**Alliance Memory, Inc.**

## Product Change Notice #20230531

<b>PCN Issue Date:</b> 31/May/2023	<b>Effective Date:</b> 30/June/2023						
<b>Subject:</b> Change in Top Marking Format for selective Alliance products. Refer affected products in Table.1							
<b>PCN Type:</b> <input type="checkbox"/> Discontinuation <input type="checkbox"/> Foundry <input type="checkbox"/> Assembly <input type="checkbox"/> Test <input type="checkbox"/> Datasheet <input checked="" type="checkbox"/> Others ( <b>Marking</b> )							
<b>Description of Changes</b>	<p style="text-align: center;">Top marking Format change</p>

<table><tr style="background-color: #e1eef6;"> <th style="width: 50%; padding: 5px;"> <b>FROM</b> Current Marking Format           </th> <th style="width: 50%; padding: 5px;"> <b>TO</b> New Marking Format           </th> </tr></table>

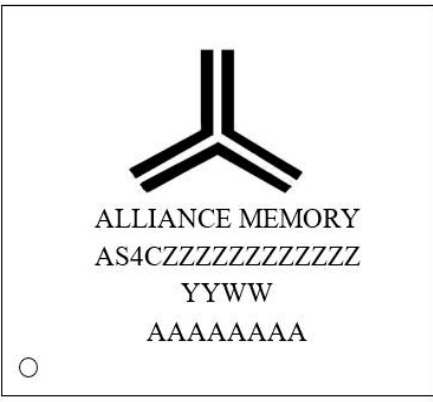
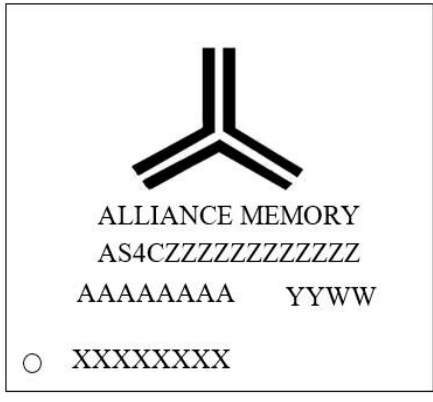
<table><tr style="background-color: #e1eef6;"> <th style="width: 50%; padding: 5px;"> <b>FROM</b> Current Marking Format           </th> <th style="width: 50%; padding: 5px;"> <b>TO</b> New Marking Format           </th> </tr><tr> <td colspan="2" style="padding: 5px;"> <ul style="list-style-type: none"> <li>BatchCode AAAA... moved to line3</li> <li>New TraceCode XXXX.... added to line4</li> </ul> </td> </tr></table>

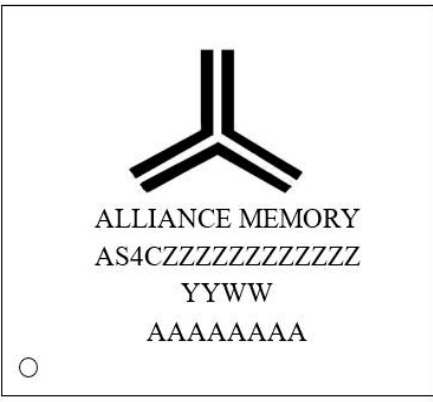
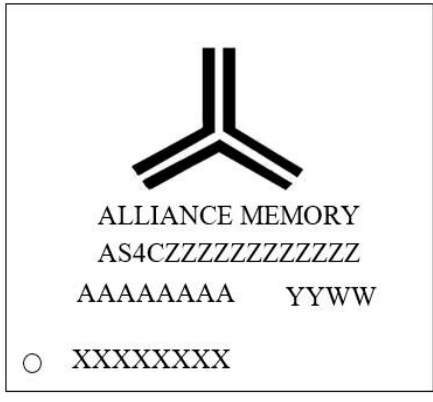
<b>FROM</b> Current Marking Format	<b>TO</b> New Marking Format			<ul style="list-style-type: none"> <li>BatchCode AAAA... moved to line3</li> <li>New TraceCode XXXX.... added to line4</li> </ul>	
<b>FROM</b> Current Marking Format	<b>TO</b> New Marking Format

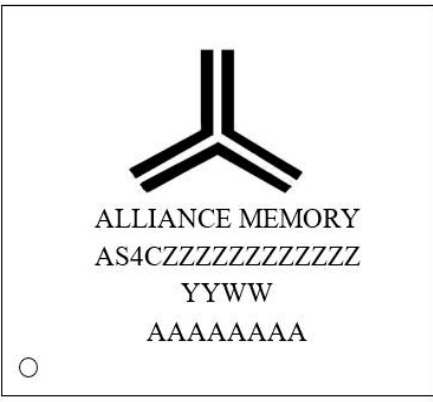
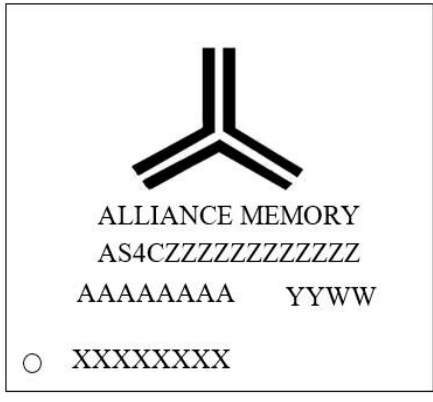
<ul style="list-style-type: none"> <li>BatchCode AAAA... moved to line3</li> <li>New TraceCode XXXX.... added to line4</li> </ul>							
<b>Reason for Change</b>	To improve production efficiency and traceability
